VILLAGE OF PALATINE

AGENDA • AUGUST 6, 2019

1. 1150 W. Euclid Avenue - Lexington Lakes
Preliminary Planned Development to permit a 26-unit residential townhome development

- **Preliminary Planned Development to permit a 26-unit residential townhome development**

SITE PLAN EXHIBIT

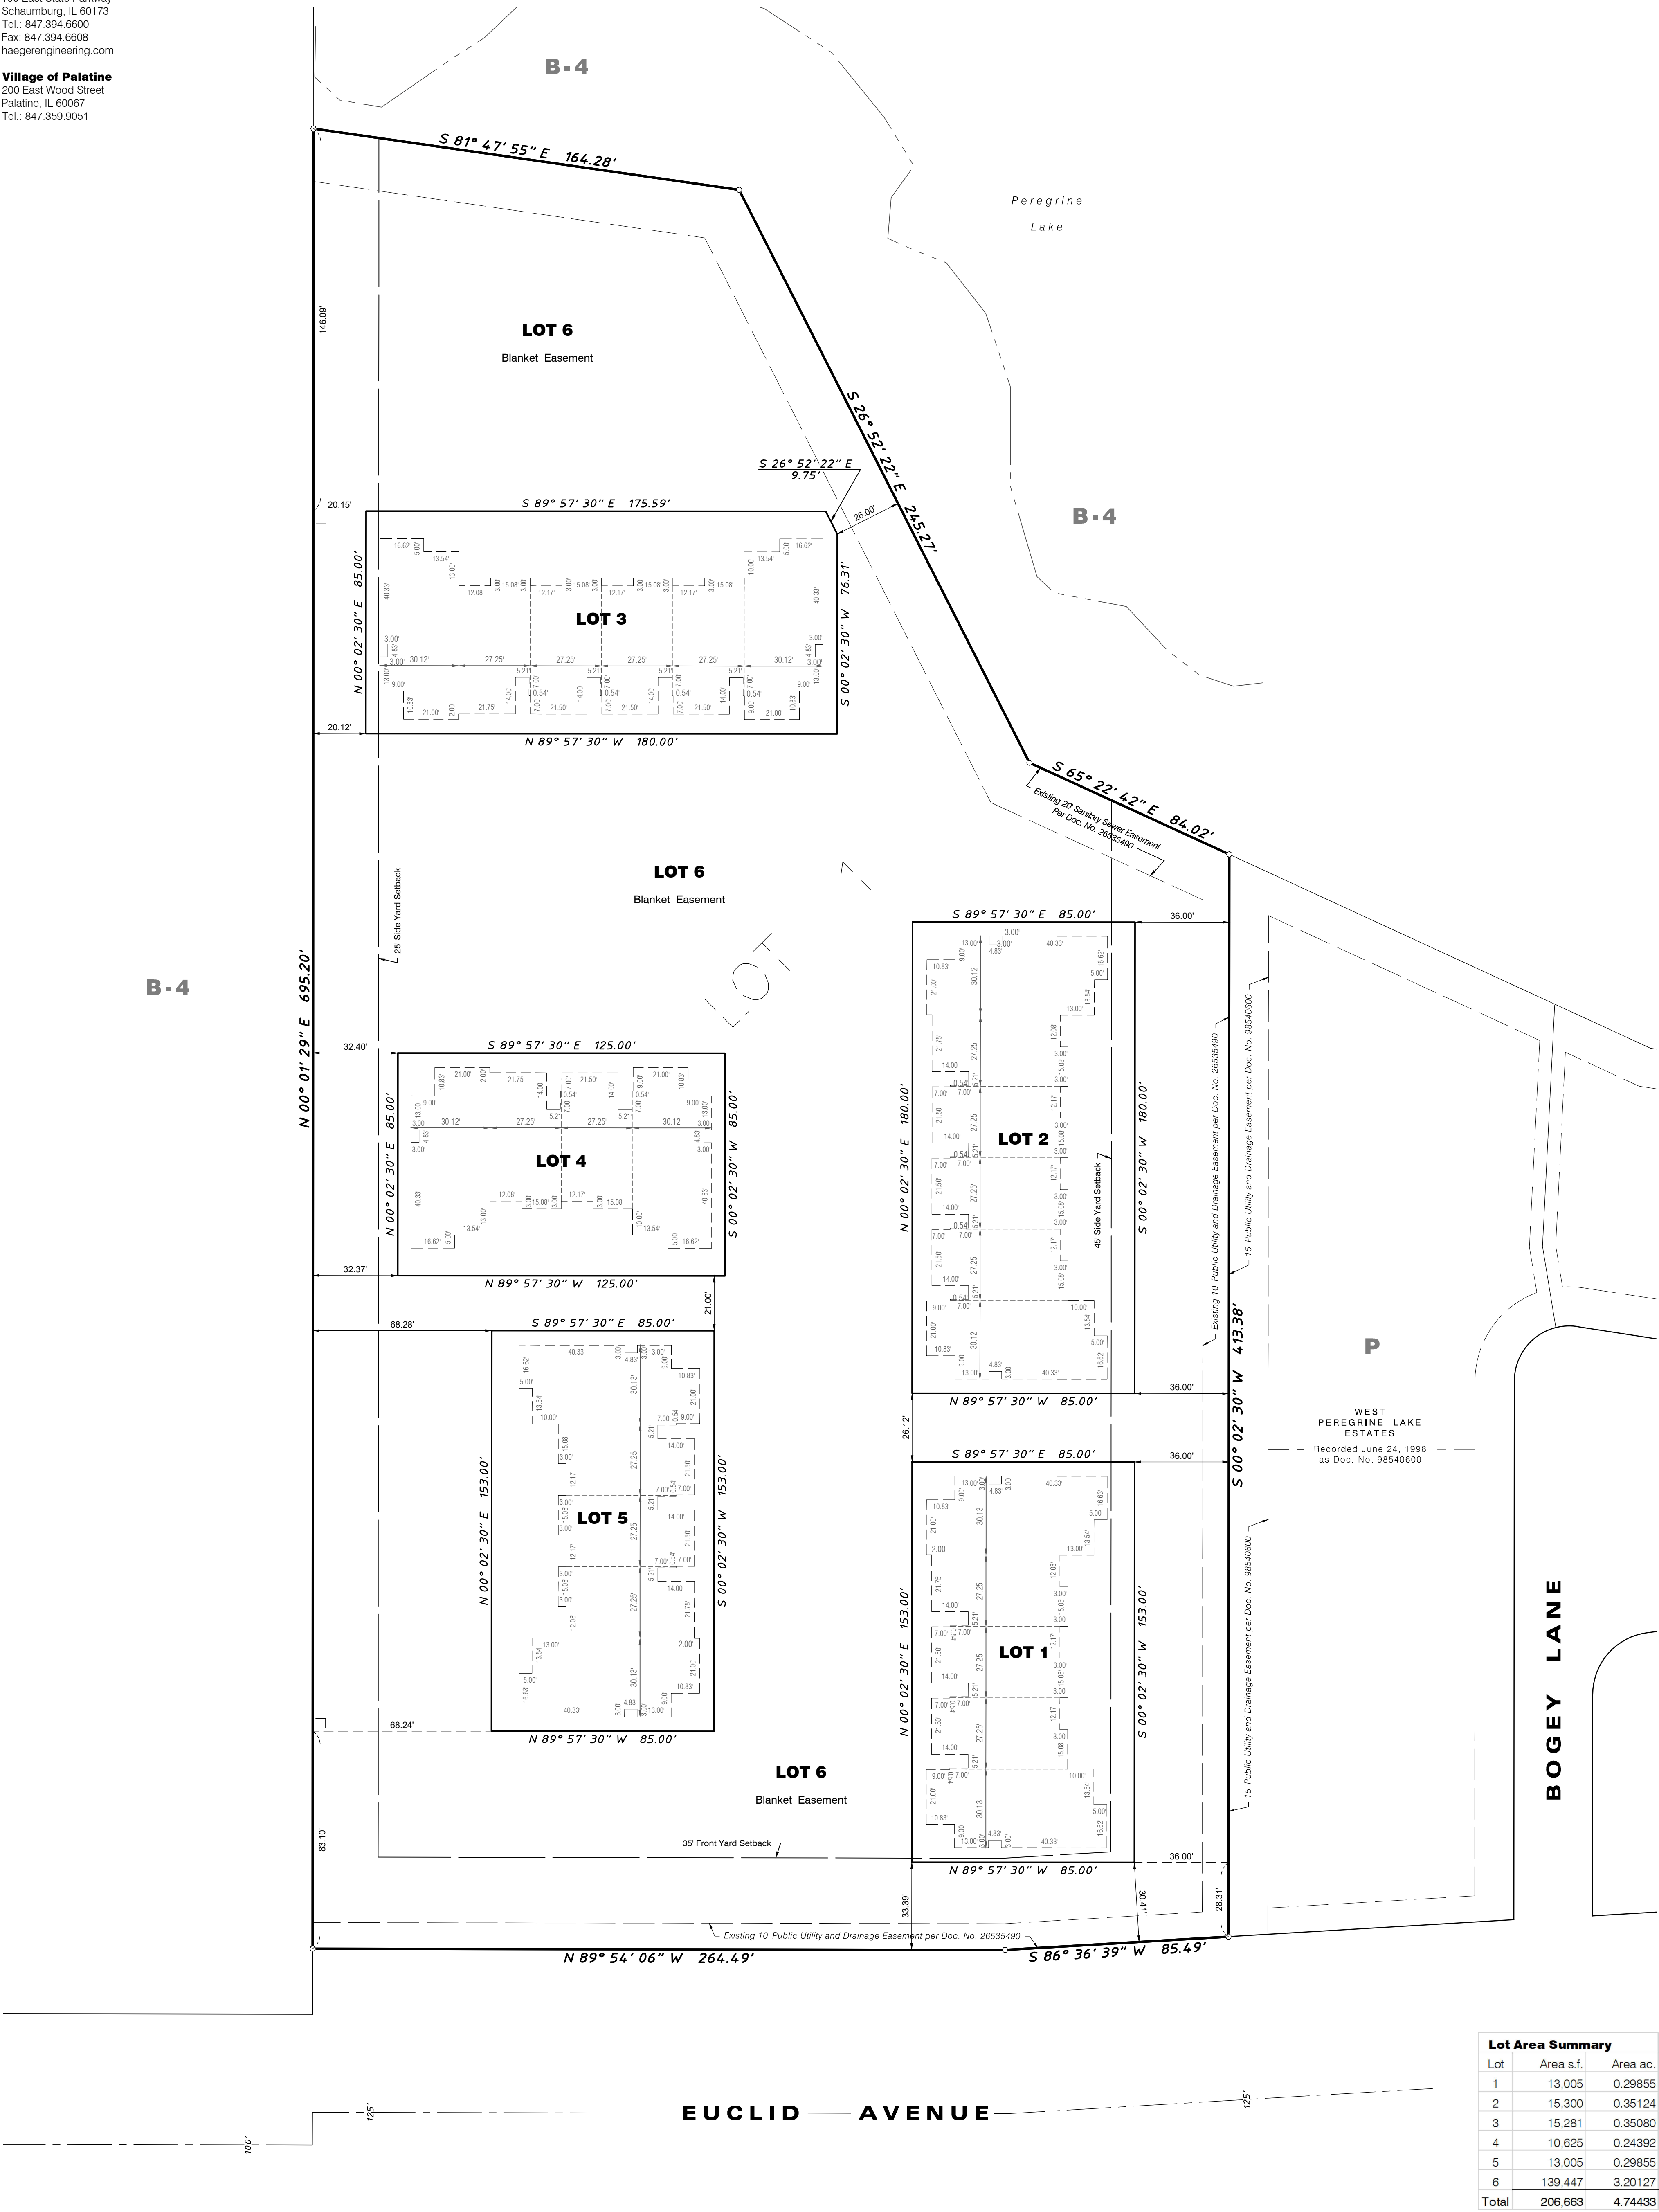
- Guest Parking - Per Section 13.03 of the Zoning Ordinance - Planned development standards - traffic circulation - the proposed guest parking spaces have been revised to eliminate the potential for traffic conflicts. While the parking spaces are distributed in the northern portion of the site only, the initially proposed guest parking spaces did not satisfy code requirements.

- Driveway Depths - The revised site plan indicates a minimum proposed driveway length of 22 feet, as previously recommended by Staff. The typical parking space has a length of 19 feet. Staff had concerns with the previously proposed driveways lengths of 20 feet due to the lack of parkway or other open space before the curb line to the street.

PRELIMINARY LANDSCAPE PLAN

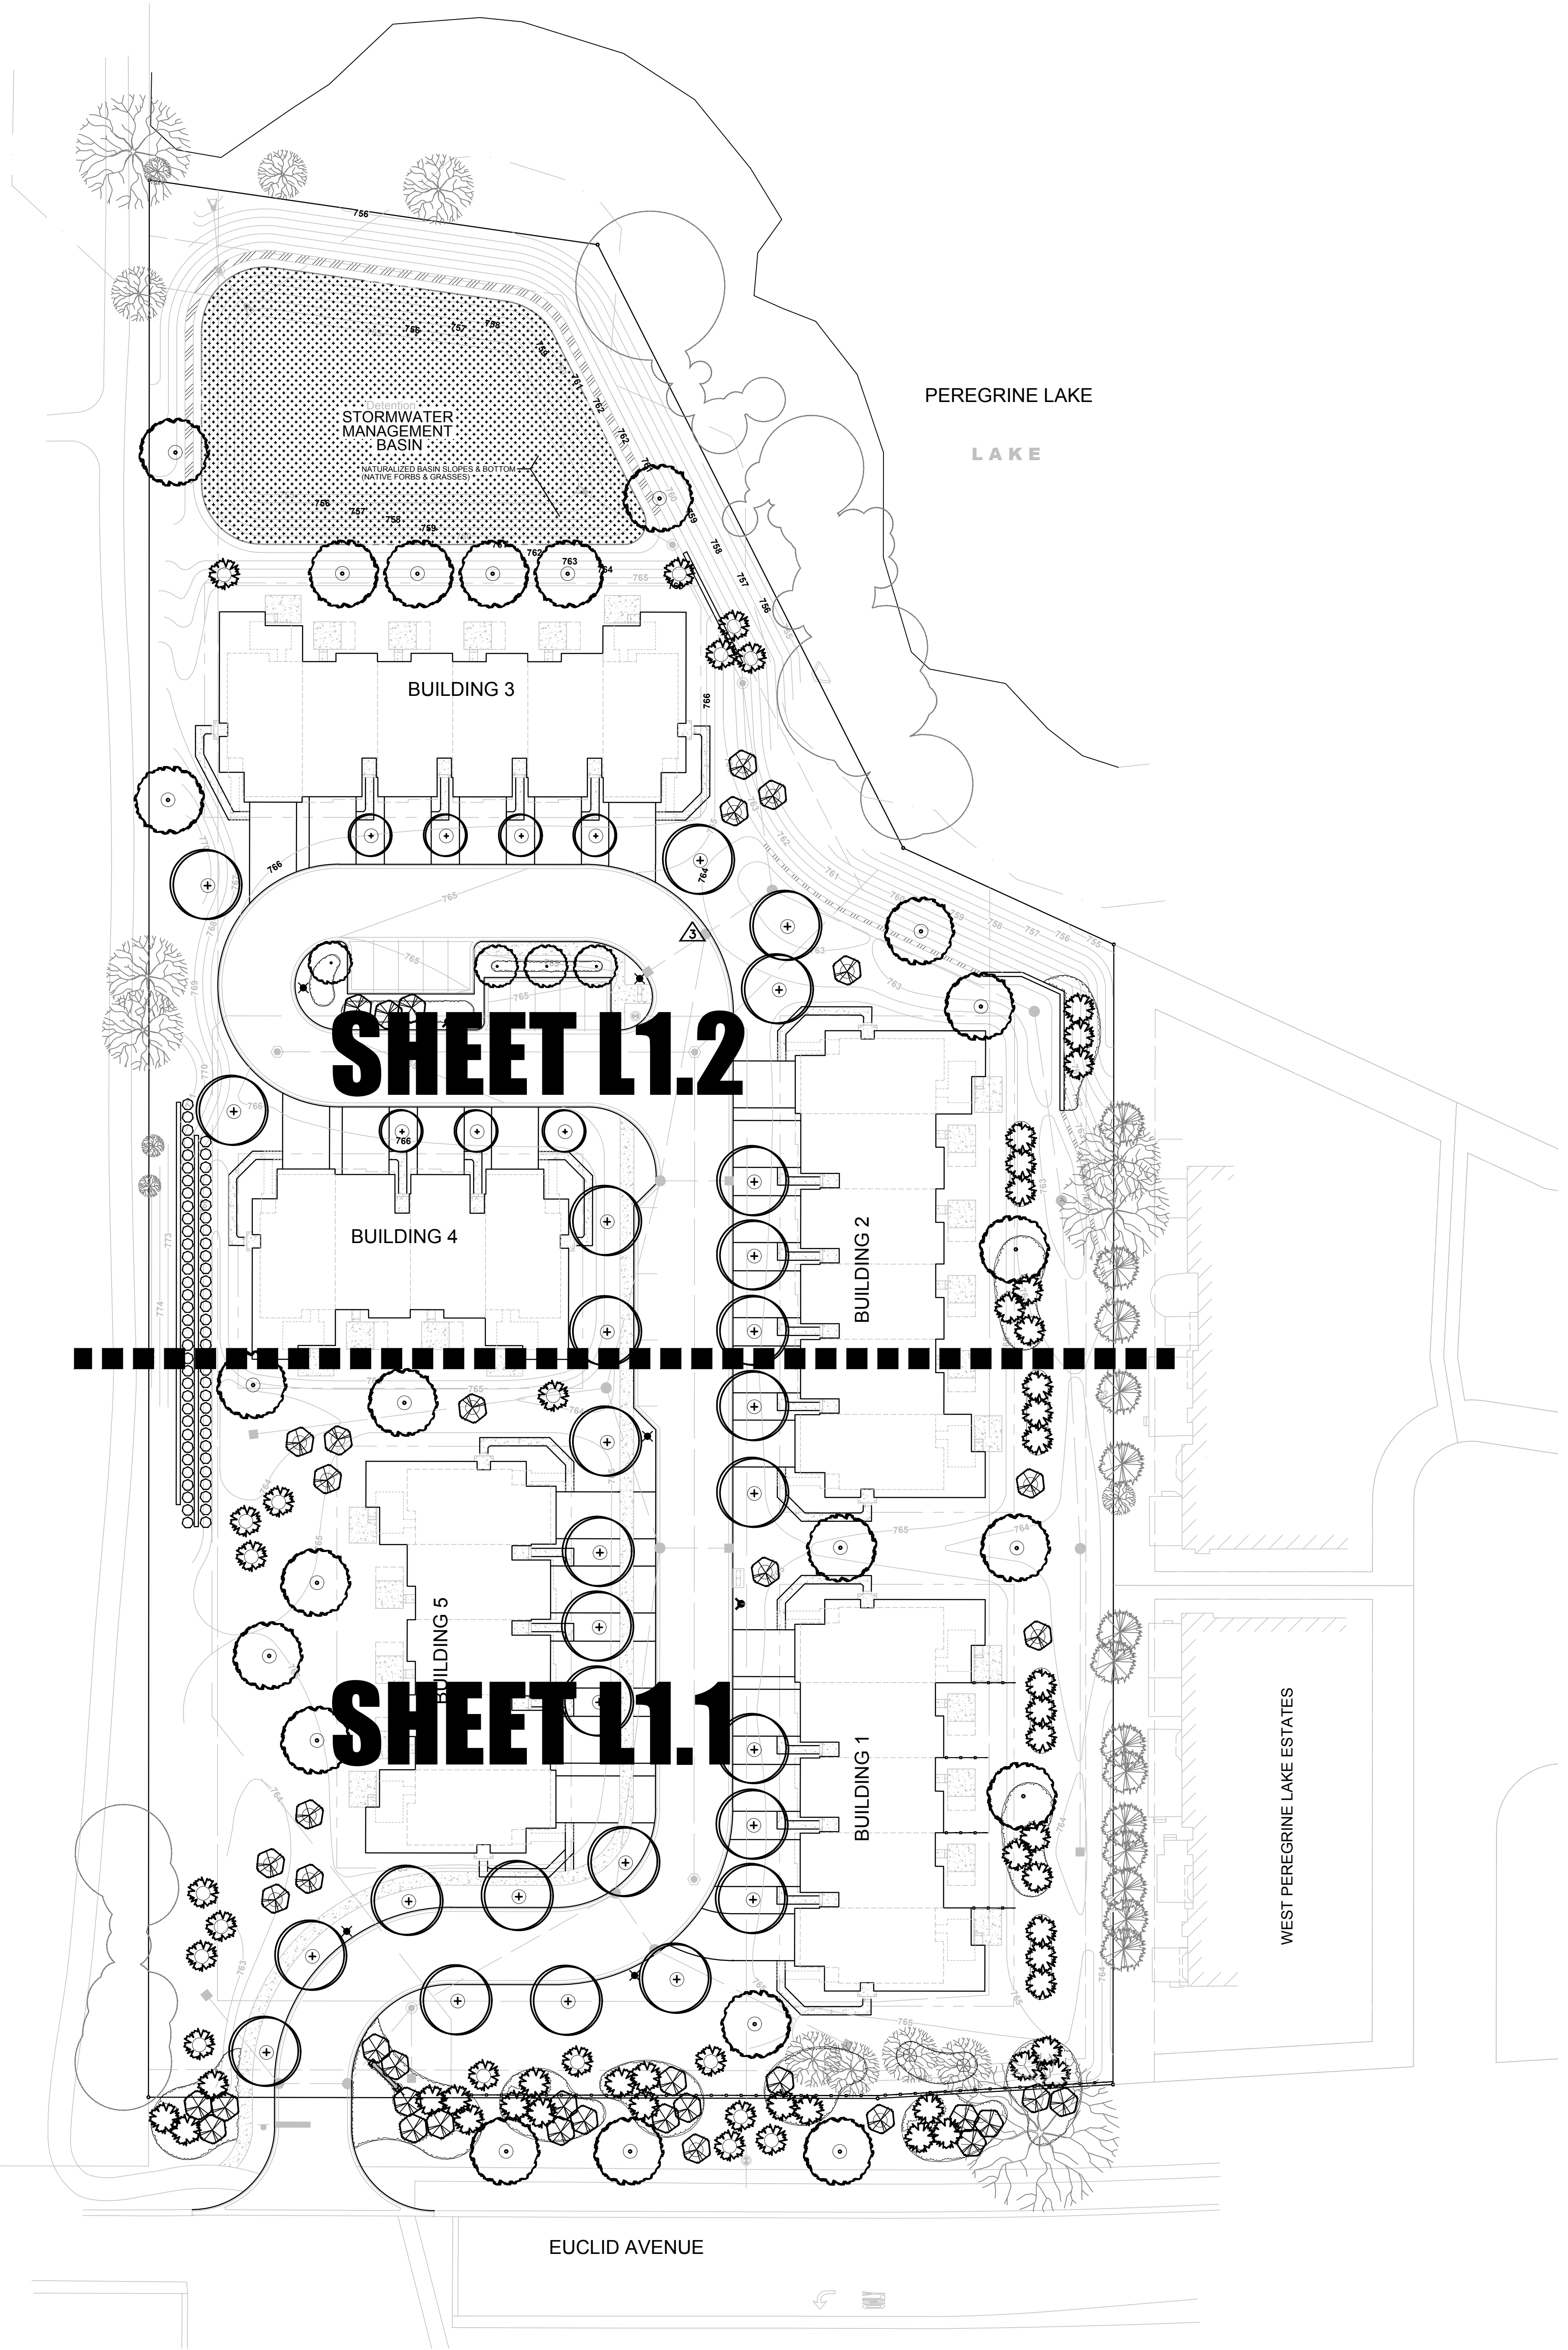
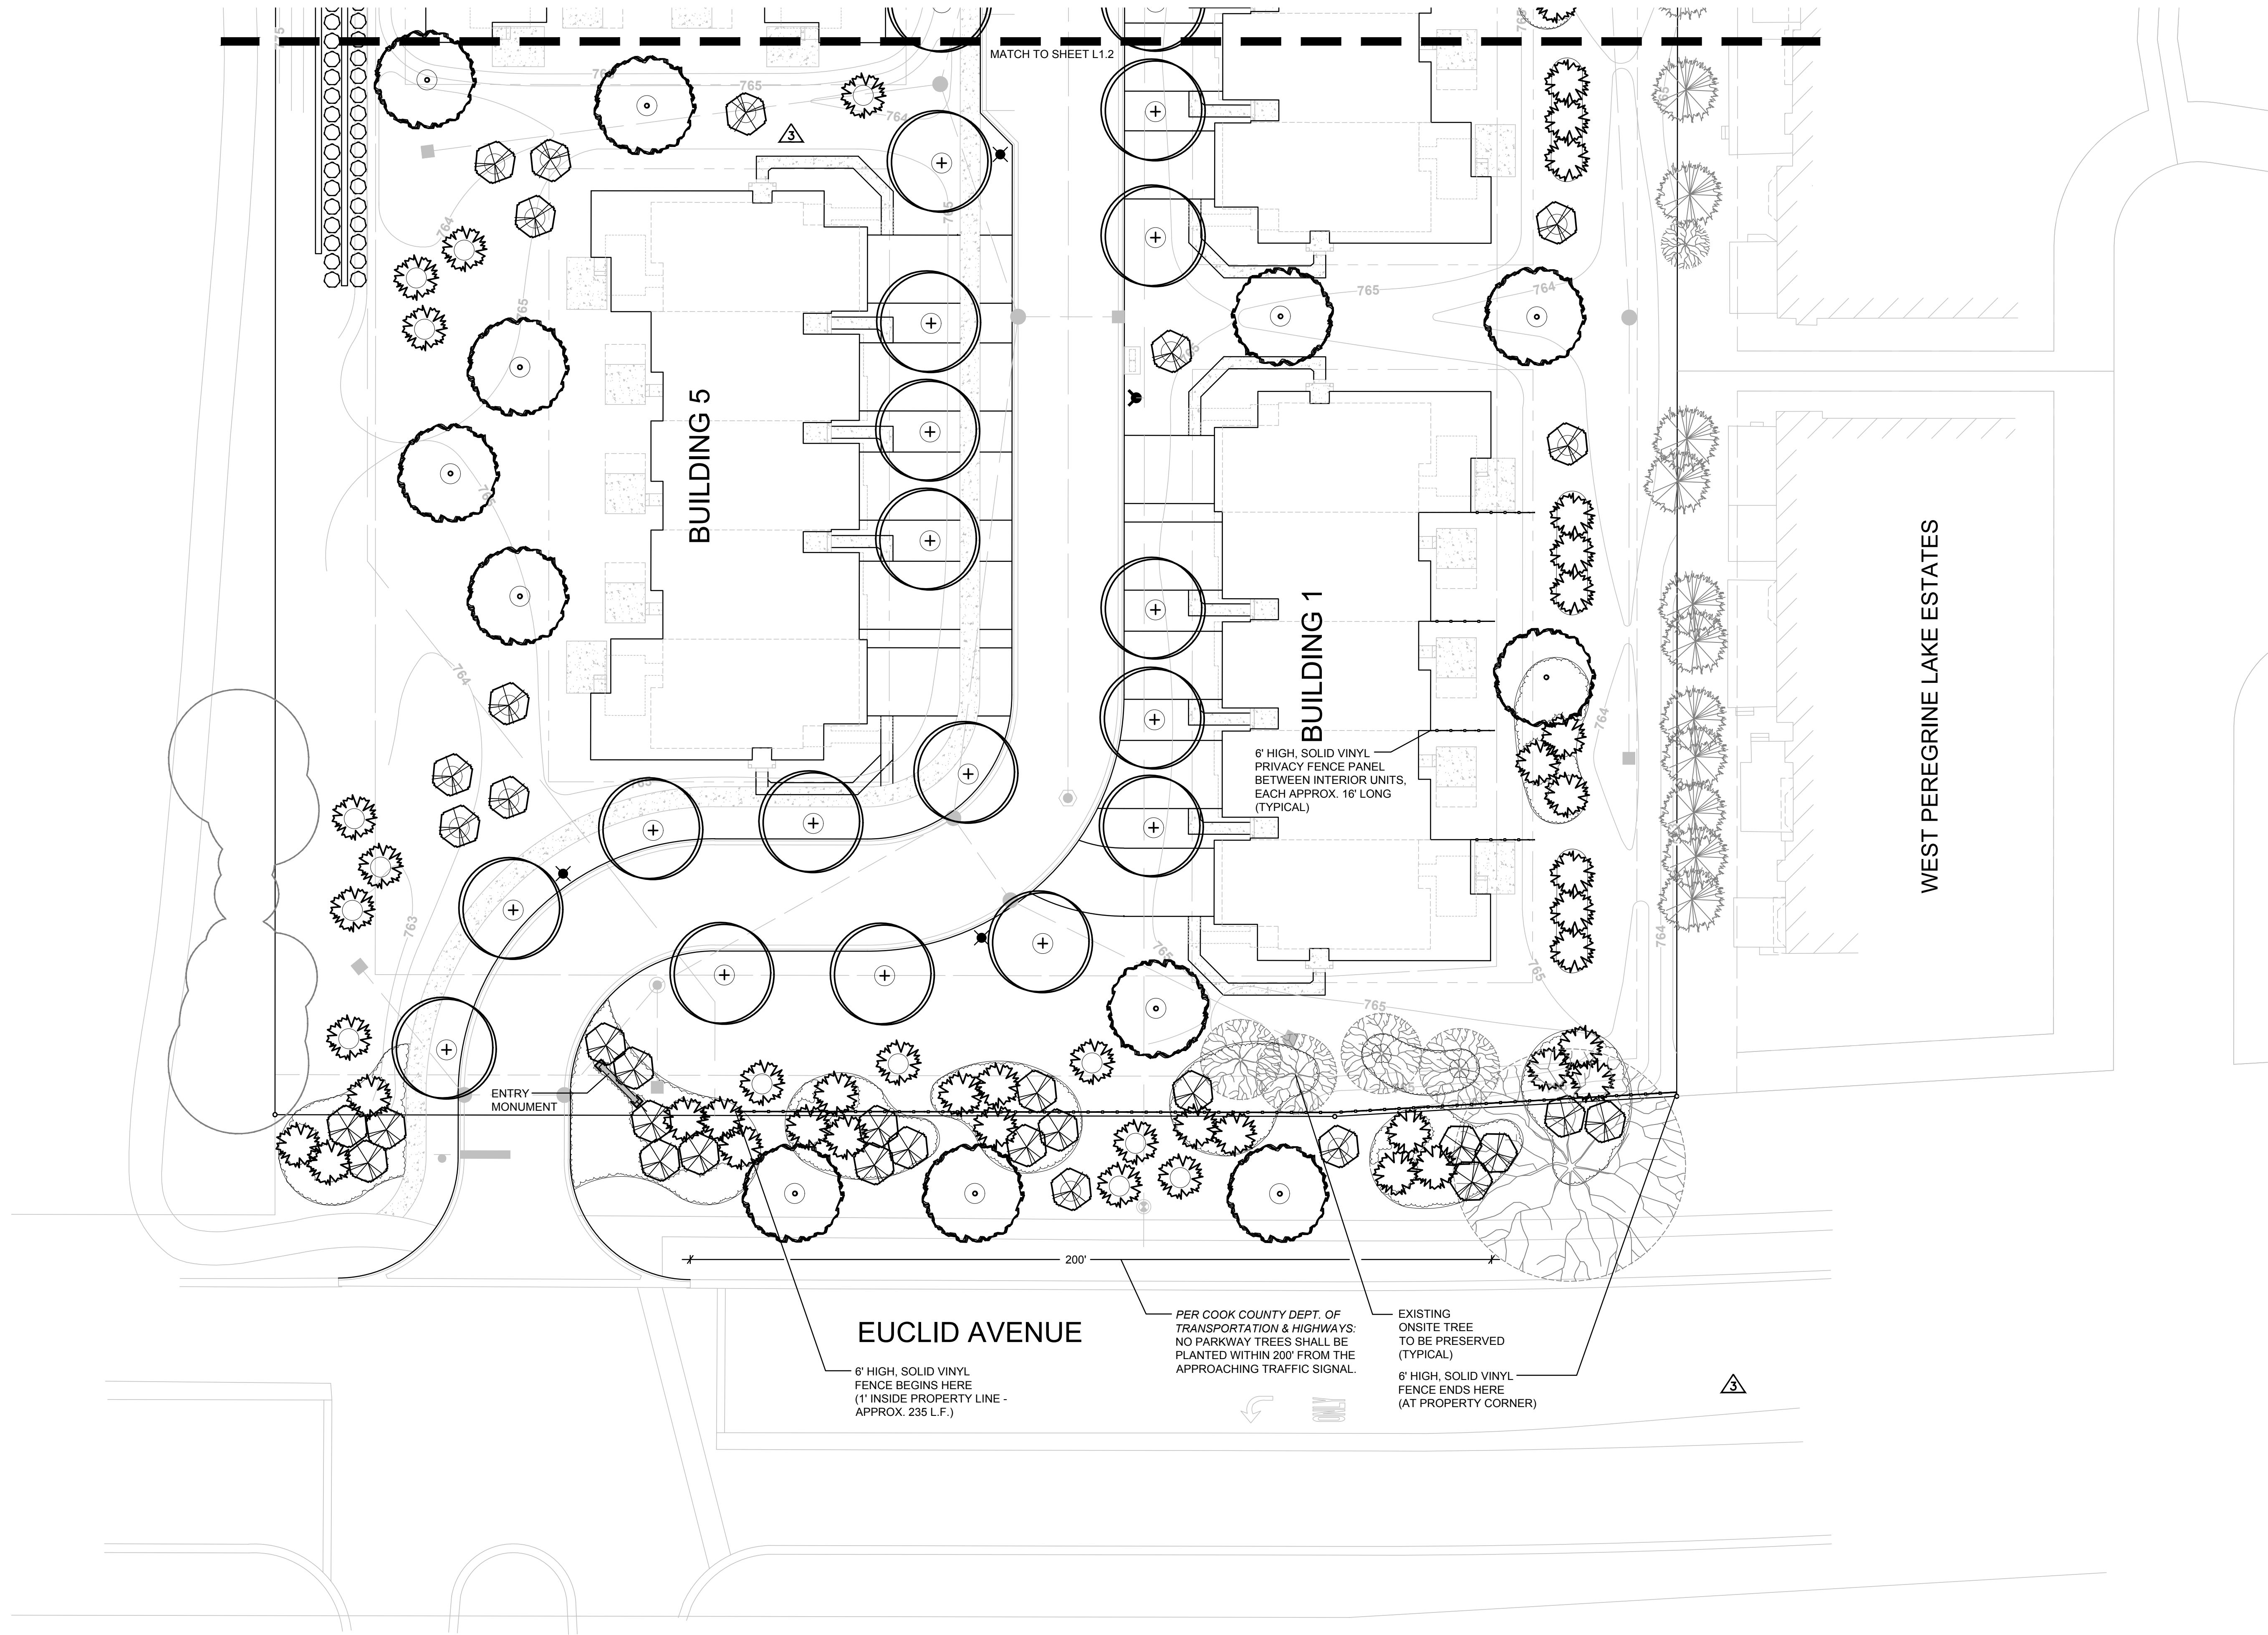
- Landscaping - The initial and revised landscape plans do not include additional foundation plantings as previously recommended by Staff. The initial landscape plan redistributed landscaping on the east side of the property at the expense of unit and foundation plantings within the site. Additionally, the 6 initially proposed parkway trees have been removed. While the landscaping plan will remain a component of final review, Staff has recommended additional unit and foundation plantings as previously proposed and this was not included in the revised landscape plans.
